## Brisbane Central Business District Bicycle User Group

I write to you on behalf of Brisbane Central Business District Bicycle User Group members to question the Howard Smith Wharves (HSW) redevelopment receiving 2020 Planning Institute of Australia awards in the categories of "Great Place Award" and "Hard Won Victory".

Figure 9 – installation of speed control platform on a 1 in 21 “walkway” of the active transport corridor

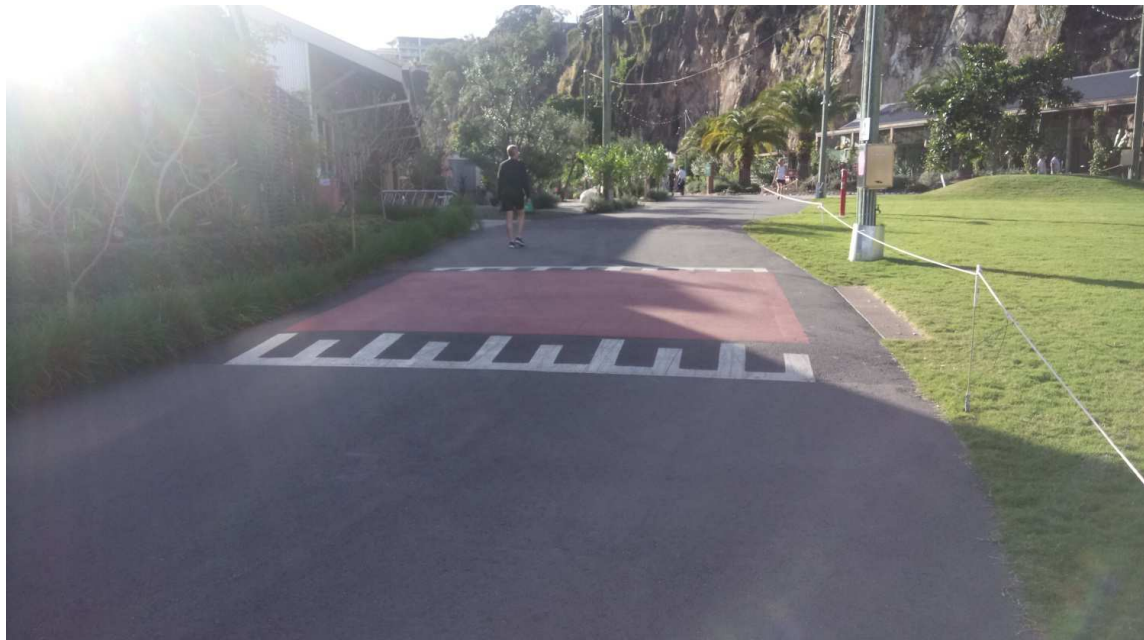
- d. even the re-constructed (sealed) path appears not comply with DDA legislation with the installation of a speed control platform on a 1 in 21 walkway. (Figure 9).

Figure 15: Heritage listed bunkers are hidden away near unsightly equipment

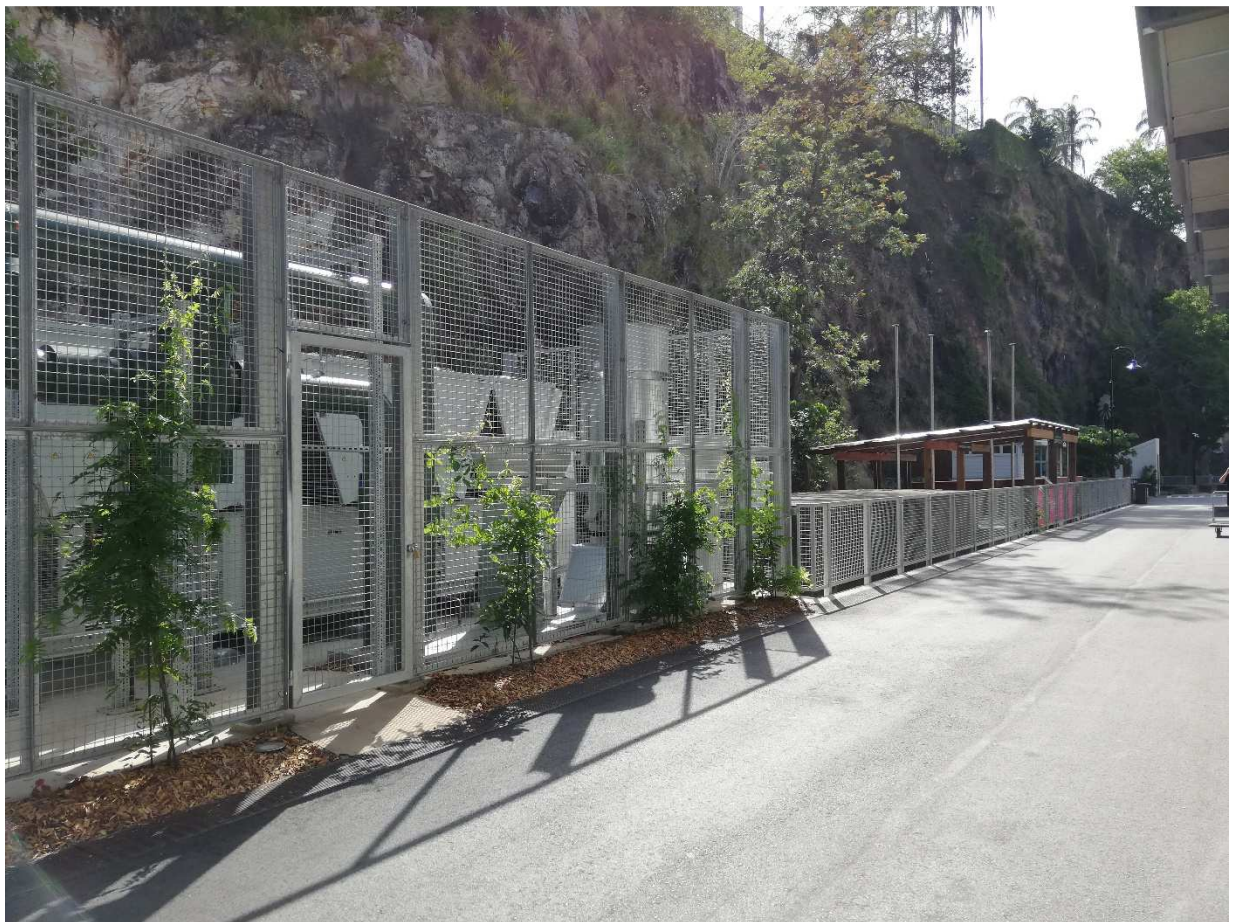
In addition to these issues impacting negatively on active transport users, other undesirable aspects from the community's perspective include the development not providing the amount of public open green space required by Council's approval, and the obstructing of public access to the heritage register-listed bomb shelters located at the rear of this site (contrary to the developers claims, these bunkers have simply been hidden out of the way, and out of sight, near unsightly equipment and machinery, Figure 16).
